HVACSYSTEM 4X210 MW KAHALGAON-R&M	SPECIFICATION NO. PE-TS-455- 571-13000A-A001	
		AMMENDMENT-1	
		DATE: 06.08.2020	
		Page 1 of 2	
AMENDMENT#1 TO EXISTING CLAUSES OF TECHNICAL SPECIFICATION			
Sl. No.	Clause	Existing description	To be read as (Amendment)

**KAHALGAON STPS (R&M) STAGE-1
(4X210)**

HVAC SYSTEM

**SPECIFICATION No.: PE-TS-455-571-
15000A-A001**

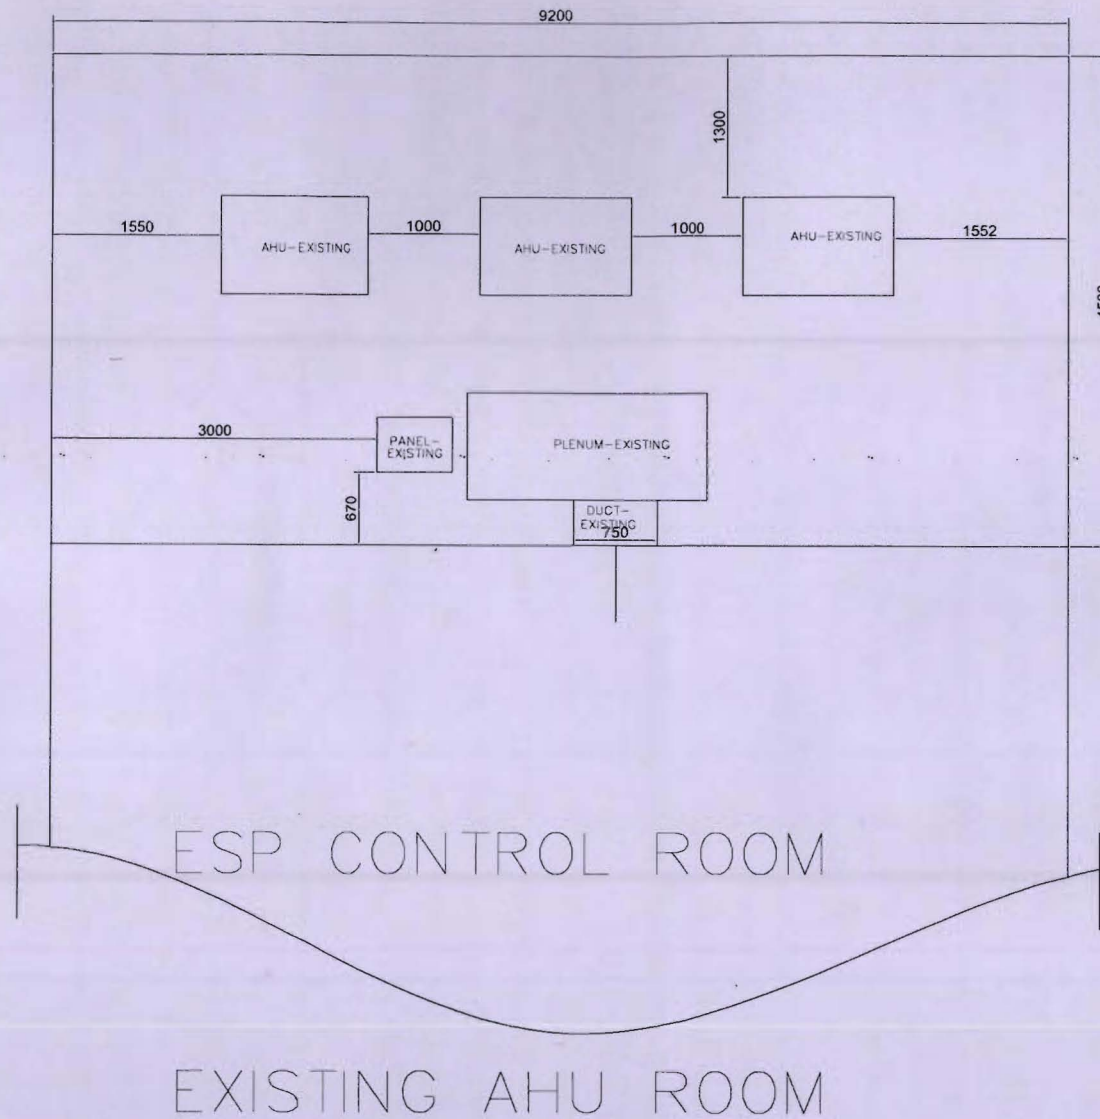
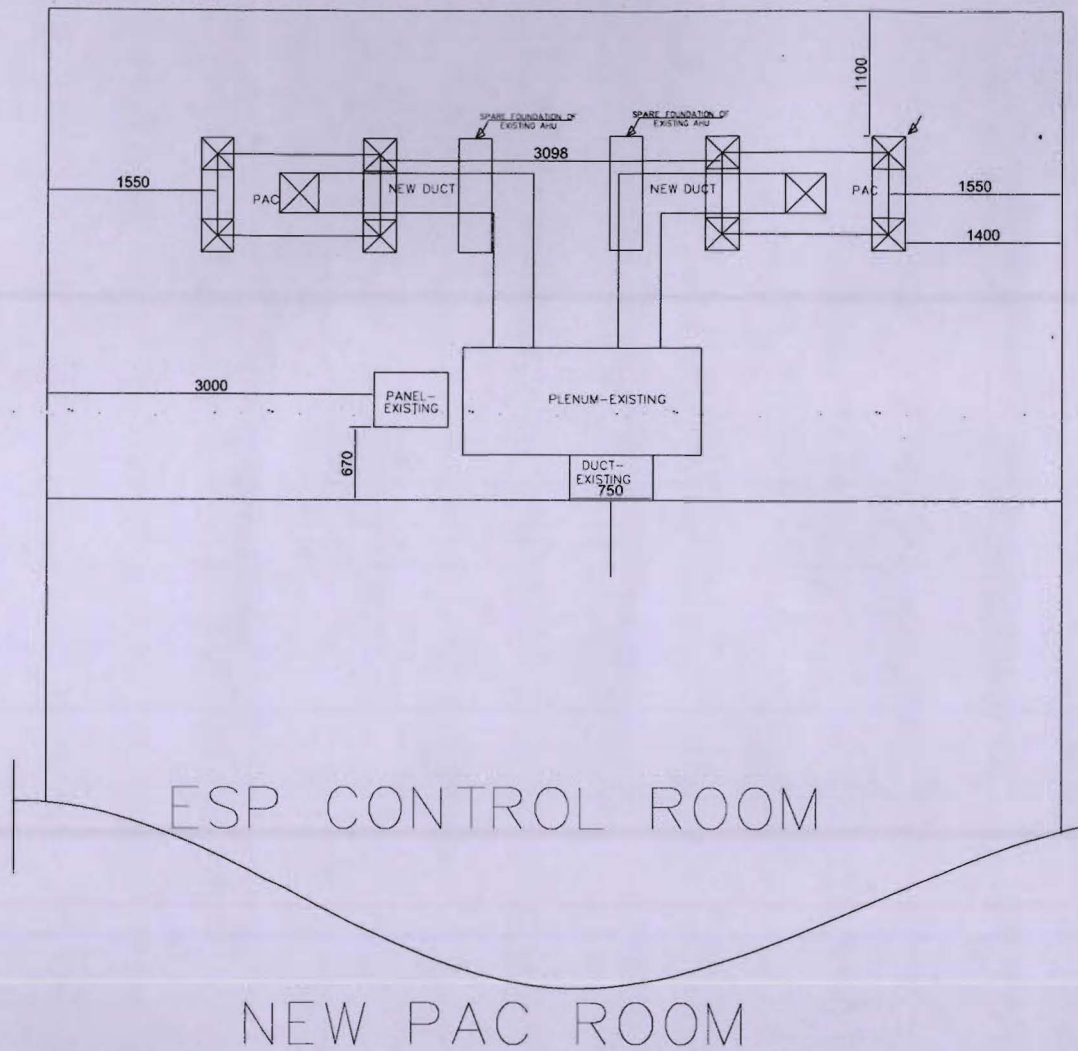
1.	Section-1, sub section-E, Annexure-1, Page 225 of 277	List of makes	Refer Revised list of makes-Annexure-1
2.	Section-1, sub section-C1, Page 10 of 277	Additional Information	PAC placed in AHU room, however outdoor unit shall be placed in above the AHU Room. Please refer tentative/proposed layout of PAC Room attached as Annexure-A, Bidder is suggested to visit site before quoting inline specification clause no. 1.12 of intent of specification
